SUBJECT: ST. LUCIE, UNIT 2 - ISSUANCE OF AMENDMENT REGARDING SPENT FUEL  
POOL STORAGE CAPACITY; SOLUBLE BORON CREDIT (TAC NO. MA0666)

AMENDMENT TO FACILITY OPERATING LICENSE

Amendment No. 101  
License No. NPF-16

SAFETY EVALUATION BY THE OFFICE OF NUCLEAR REACTOR REGULATION  
RELATED TO AMENDMENT NO. 101 TO FACILITY OPERATING LICENSE NO. NPF-16  
REGARDING BORON CREDIT IN THE SPENT FUEL POOL  
FLORIDA POWER AND LIGHT COMPANY, ET AL.

**Figure 5.6-1a**  
**Required Fuel Assembly Burnup vs Initial Enrichment and Decay Time**  
**Region II, 1.3 w/o**

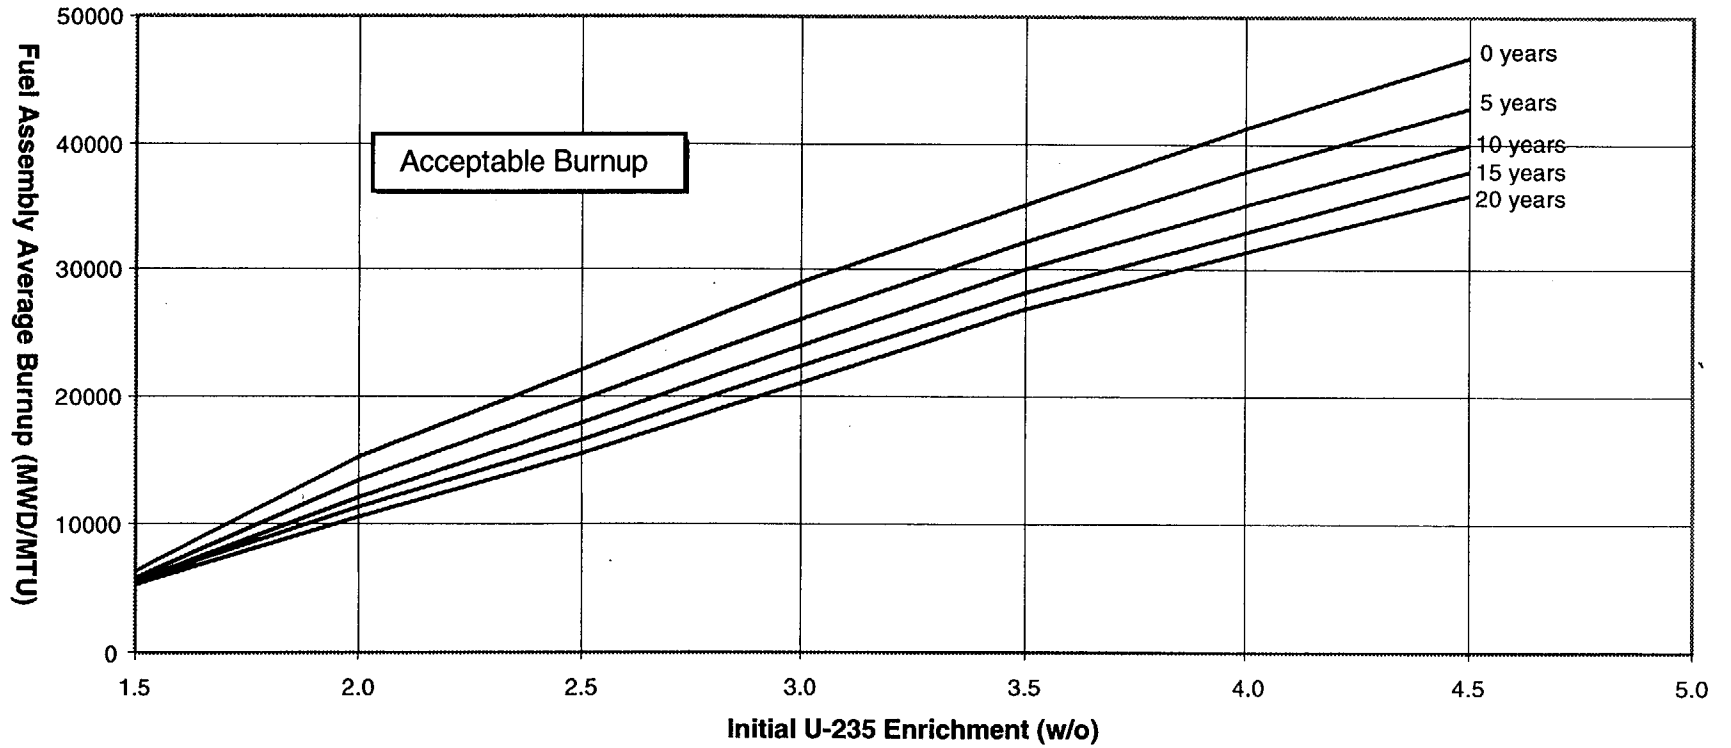
1. Fuel placed in Region II shall meet the burnup and decay time requirements specified in Figure 5.6-1a or 5.6-1b.
  2. The reactivity effect of CEAs placed in fuel assemblies may be considered.

FPL proposes to modify TS 5.6 to permit an increase in the storage capacity of the spent fuel pool storage racks from 1076 to 1360 assemblies. TS Figure 5.6-1 would be removed and new Figures 5.6-1a through 5.6-1e would be added to describe the assembly burnup requirements for Region 1 and 2 of the spent fuel pool. The TS changes proposed are consistent with the revised criticality analysis evaluated above. Based on this consistency and on the use of approved methodology, the staff finds these TS changes acceptable.

**Figure 5.6-1c**  
**Required Fuel Assembly Burnup vs Initial Enrichment and Decay Time**  
**Region I, 1.4 w/o**

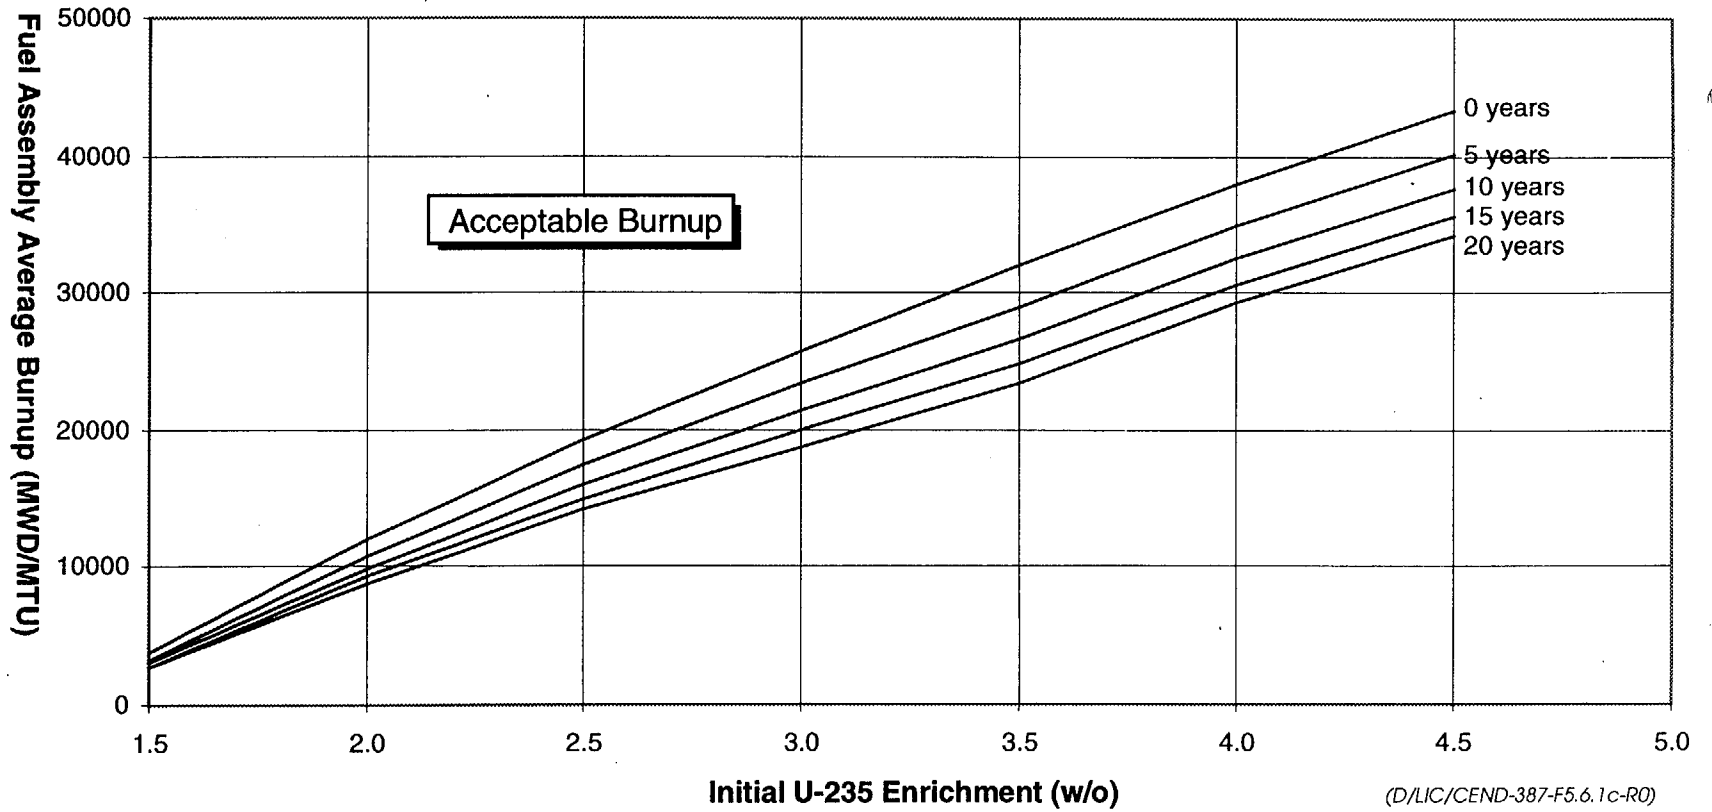
3. The reactivity equivalencing effects of burnable absorbers may be considered.
  4. The reactivity effects of fuel assembly burnup and decay time may be considered as specified in Figures 5.6-1c through 5.6-1e.
